Document Title: MAINTENANCE BULLETIN – S-MN-MB-001v0			 Simpsonville, South Carolina	
Erema Melt Temperature Probe Bushing Modification				
Document Number: S-MN-CRD-XXX	Rev No: 01	Date: 05/05/14	Document Owner: Reliability & CI Manager	Approver(s): Maintenance Manager

- 1.1. This document describes and details the modification/s and requisite task/s instructions in original equipment manufacturer design in the SC1 Erema melt temperature probe bushing at the Fitesa, Simpsonville plant, SC.

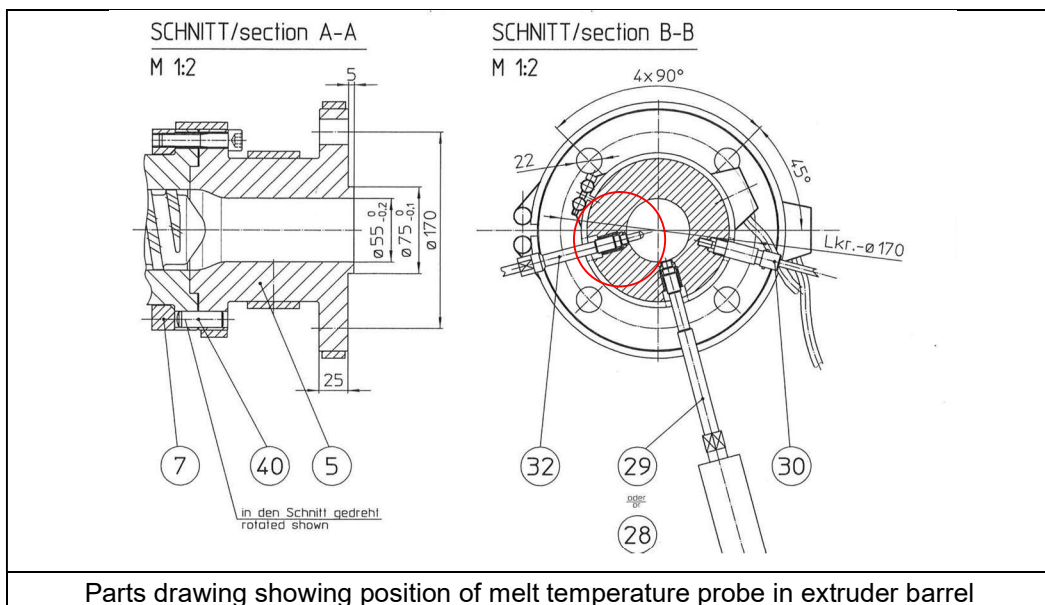
- 7.1. Following a physical analysis it was determined that there was insufficient lateral support of the tip of the probe and that longitudinal forces of the plastic melt flow was greater than the ability of the base of the probe tip to withstand being 'bent' to the point of the metal sleeve and mica fill of the probe would result in breaking down the molecular physical bonds and separate – failed state.

- 7.2. Reducing the moment of the tip of the probe to the base of the probe would negate this moment to the point where the surface contact of the length of the probe with the plastic melt flow to an extent the probe tip could withstand lateral forces of the plastic melt flow against it.

7.4. Modified part drawing

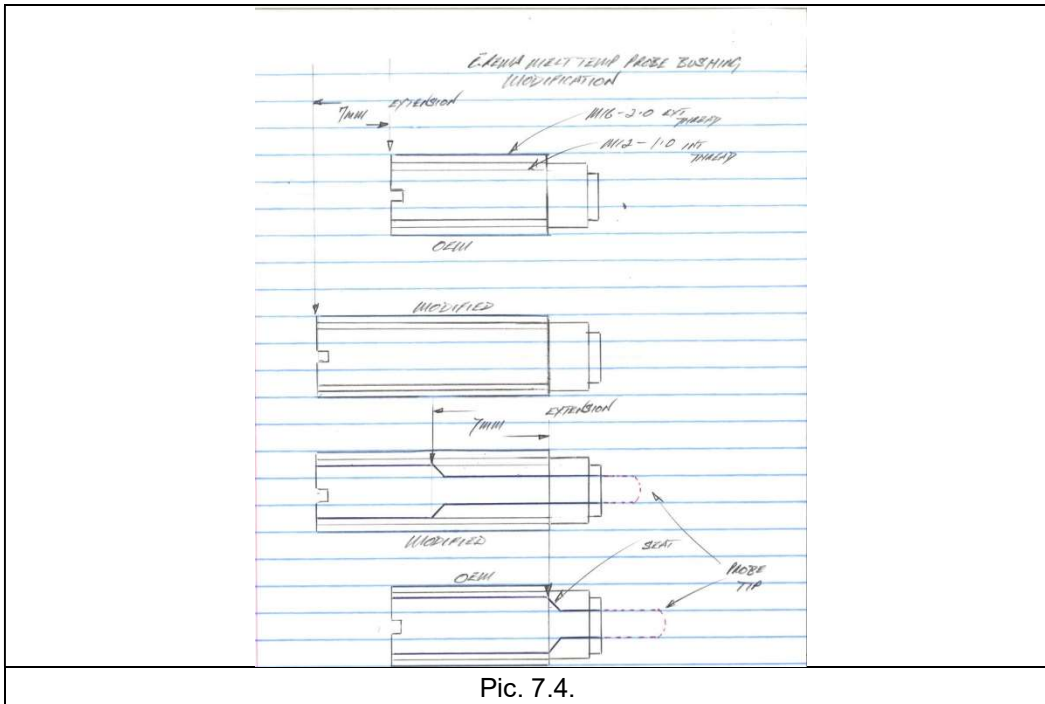
- 7.3. The probe has two parts; the probe itself and the bushing that it inserted to and then inserted into the extruder barrel directly into the plastic melt flow. The bushing has been modified to reduce the distance the probe extends into the plastic melt flow by 50%. Currently the probe extends 14 mm into the extruder barrel. This has now been reduced to 7 mm. This is not expected to affect the ability of the probe to accurately measure the plastic melt temperature. To achieve this modification of the bushing was necessary. The external and internal threaded body of the bushing has been increased by 7 mm. The internal seat of the bushing where the probe seal against the bushing has been moved 7 mm backwards thus is reducing the extension of the probe tip into the barrel by 7 mm. See pic 7.4

C-AREA MELT TEMP PROBE BUSHING MODIFICATION

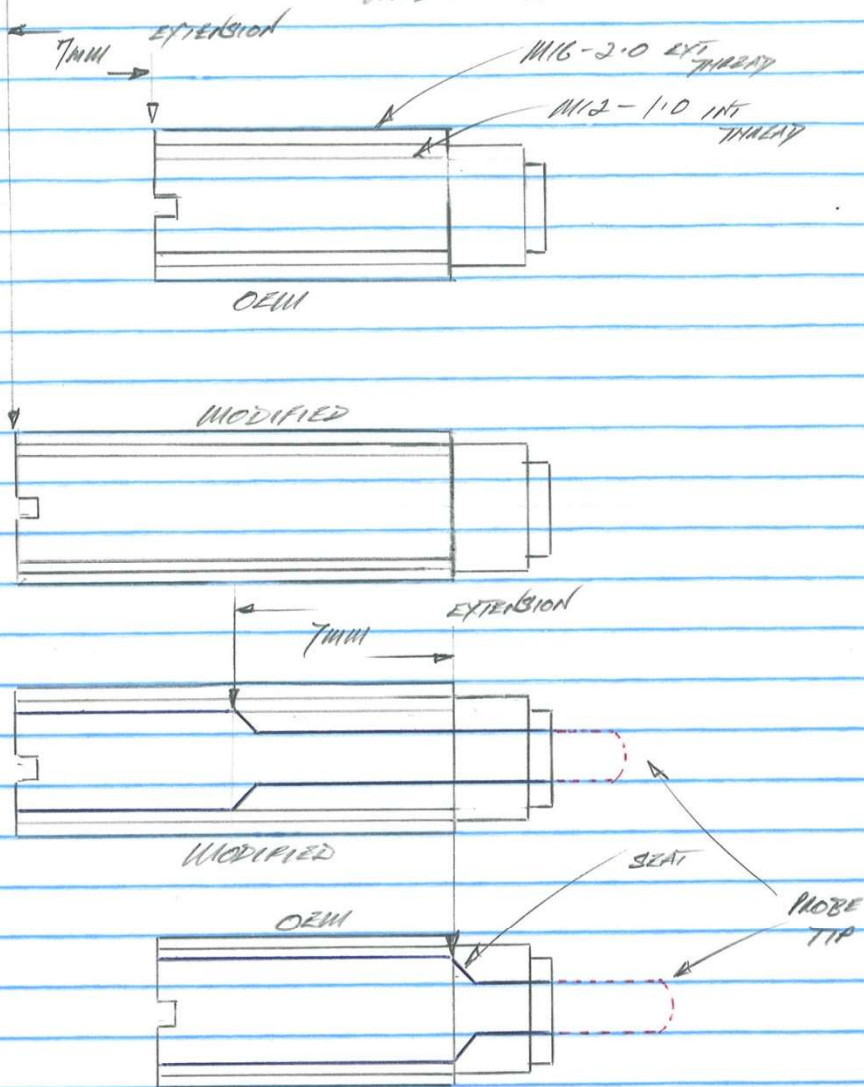
13. ATTACHMENT 1: Modified bushing drawing.
